Design Standards Update

2014 Design Standards eBooklet

Index 304 – Detectable Warnings and Sidewalk Curb Ramps

Index 310 – Concrete Sidewalks

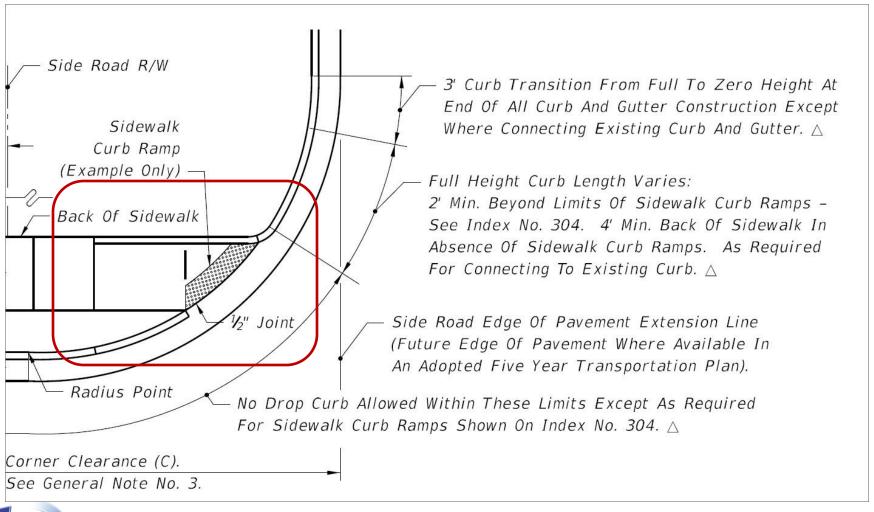
- Other Design Standards:
 - ✓ Index 310, Index 515, and Index 17346.
- Specifications Revisions:
 - ✓ Sections 520, 522, and 527.
- Basis Of Estimates (BOE) Revisions:
 - ✓ Pay Item 522 and Pay Item 527.

IDS-304 (Design Aid for CR-F)

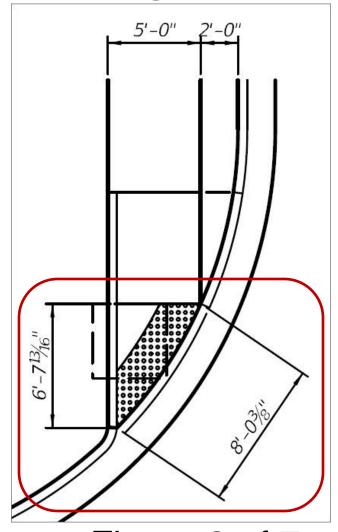
Table of Detectable Warnings

CR-F:

25' Radius,

13 SF

Sheet 3 Mark-up of Figure 1:

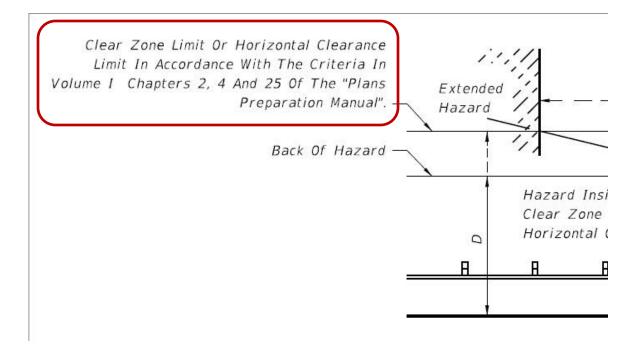
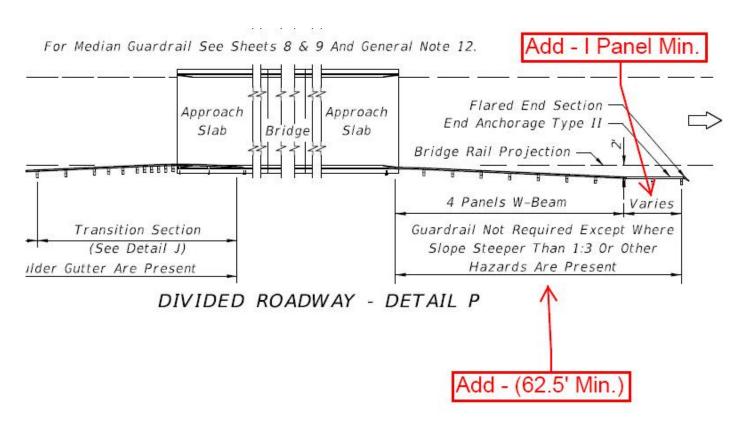
Clear Zone Limit Or Horizontal Clearance Limit In Accordance With The Criteria In Volume I Chapters 2, 4 And 25 Of The "Plans Preparation Manual", and Index No. 700.

≤ 45	= 16 (D-d)	
≥ 50	= 13 (D-d)

Sheet 6 Mark-up of Detail P:

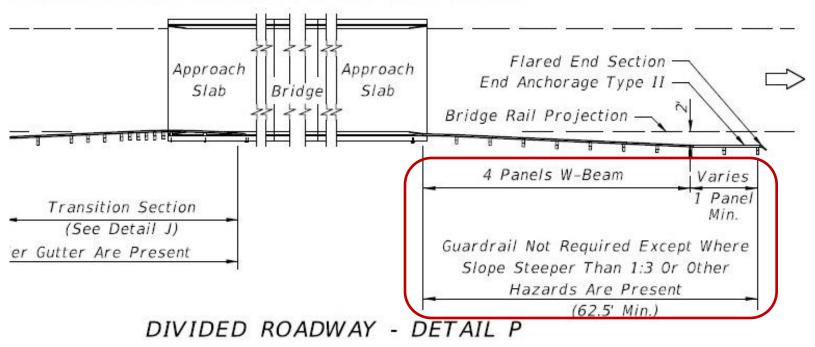
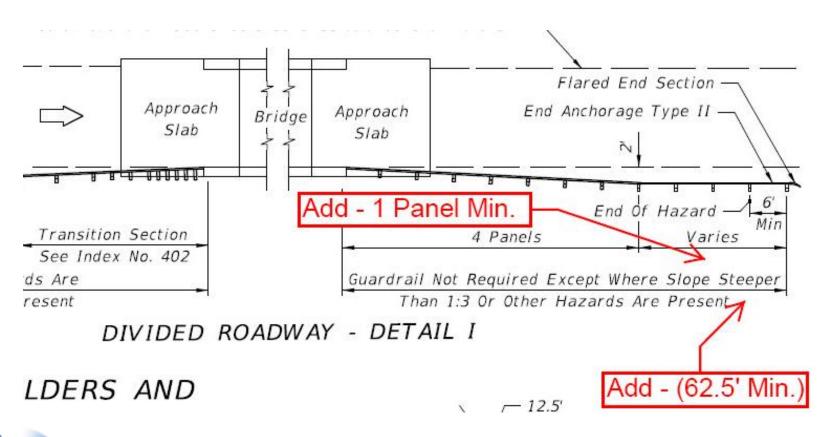
For Median Guardrail See Sheets 8 & 9 And General Note 12.
